Access Compliance Report

Public Rights-of-Way

(Curb Ramps)

Intersection ID: 24485	Main Street: CAMAROSS_DR	Cross Street: SAINTFIELD_PL	Location: NW
ADA ID: 825859DD73F9	Ramp Type: Perp	Initial Pass/Fail: Fail	Overall Compliance: No
Severity Score: 8.75			
Codes/Mitigation Info/Possible Solution		Field Measurements/Component Compliance

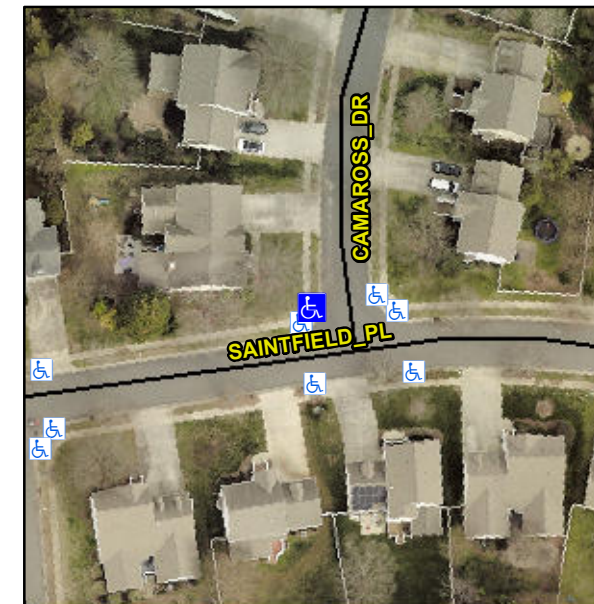
Not Found, R304.5.1

Compliance	Description	Data	Compliance	Description	Data
N/A	Ramp Length (in)	48.0	Yes	Ramp Slope (%)	5.6
No	Ramp Width (in)	37.0	Yes	Ramp XSlope (%)	0.6
N/A	Flare Type LT	N/A	N/A	Flare Type RT	N/A
N/A	Flare Slope LT (%)	N/A	N/A	Flare Slope RT (%)	N/A
N/A	Flare Traversable LT?	N/A	N/A	Flare Traversable RT?	N/A
N/A	Landing Length (in)	N/A	N/A	DWS Provided?	N/A
N/A	Landing Width (in)	N/A	N/A	DWS Contrast?	N/A
N/A	Landing Slope (%)	N/A	N/A	DWS Length (in)	N/A
N/A	Landing X Slope (%)	N/A	N/A	DWS Full Width?	N/A
N/A	Landing Curb? (Y/N)	N/A	N/A	DWS Offset (in)	N/A
N/A	Shared Landing?	N/A			
N/A	Gutter Ponding?	N/A	N/A	Gutter Slope (%)	N/A
N/A	Gutter Lip Ht (in)	N/A	N/A	Gutter X Slope (%)	N/A
N/A	Painted X Walk1?	No	N/A	Painted X Walk2?	N/A
	X Walk 1 Direction	To E		X Walk 2 Direction	N/A
N/A	X Walk 1 Width (in)	N/A	N/A	X Walk 2 Width (in)	N/A
	X Walk 1 Slope (%)	2.7		X Walk 2 Slope (%)	N/A
	X Walk 1 X Slope (%)	2.0		X Walk 2 X Slope (%)	N/A

Remove & Replace Entire Ramp.
